Quality Control Check Report. Stage: After Finishing Stage III (Apartments)

MAYFLOWER PLATINUM

Details of Additions & Alterations

Flat No	506	Block no.	'A'
Flat Area	1800 sft	Type	Deluxe / Luxury
Buyer Name	Ankita Patnaik/Rakesh Kumar Pattnaik		
Phone No.	9748299552/9494019552	Email	rakeshkumar-pattnaik@yahoo.in

Description	Direction	Owners & Developers :	Date :	18.03.2020	Promoted by
WORKING DRAWING OF FLAT.NO.A-6		Modi Properties Pvt Ltd.	Prepared By :		
		Project Name & Phase :	Approved By :	Soham Modi	Modi Properties Pvt. Ltd
		MAYFLOWR PLATINUM	Scale :	N.T.S	Phone:+91-40-66335551

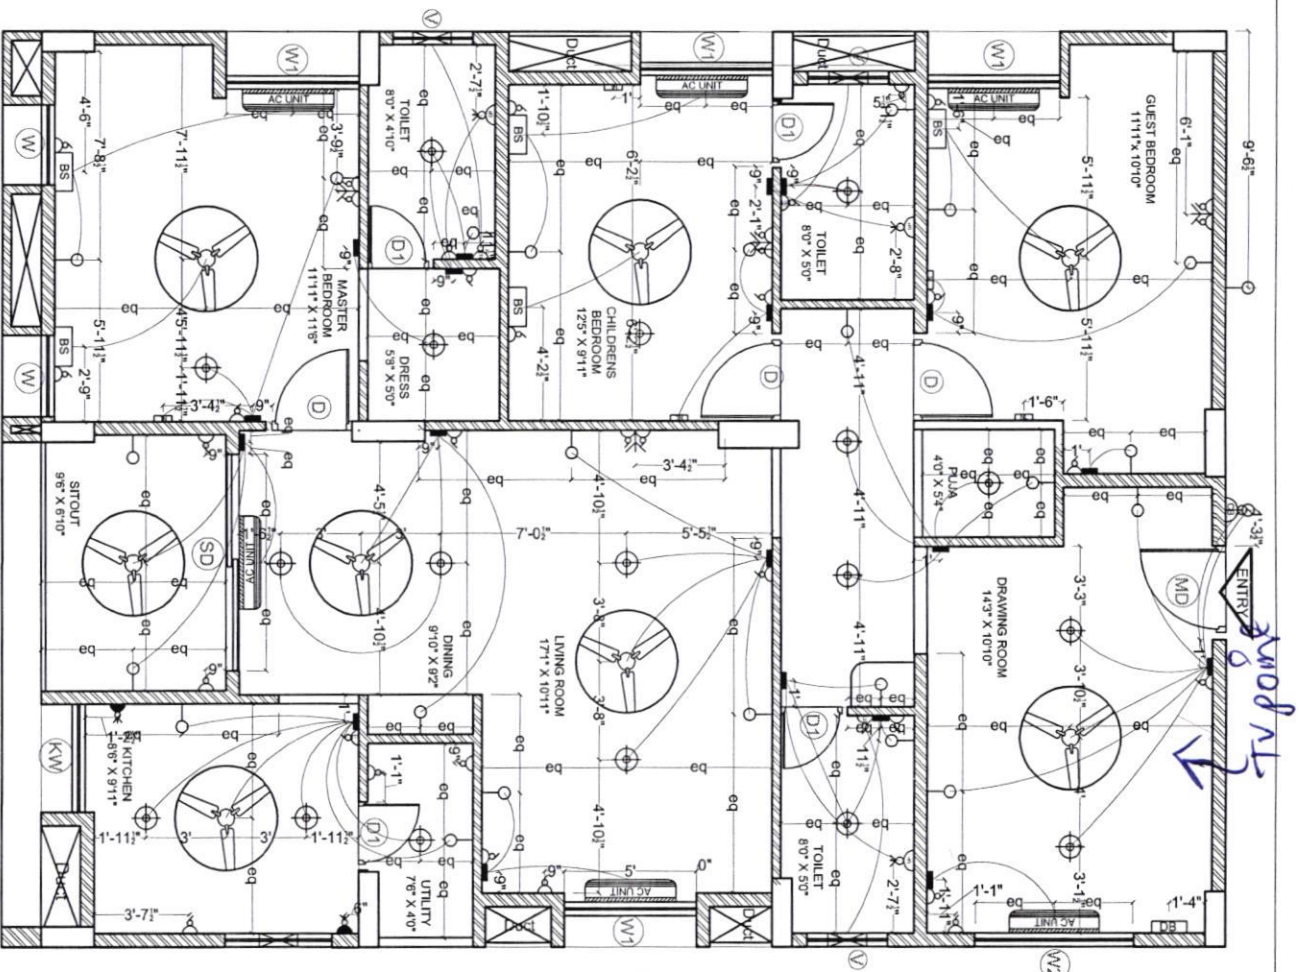
Changes in electrical points: (mark on plan)

- ① Kitchen - 2 extra plug point 16 amp
- ② Dressing room - 1 plug point for wall fan & light
- ③ Wash basin - 1 plug point & light point
- ④ 1 Extra plug point at dining area
- ⑤ TV point in drawing room at Entrance wall
- ⑥ All washroom extra Exhaust Fans
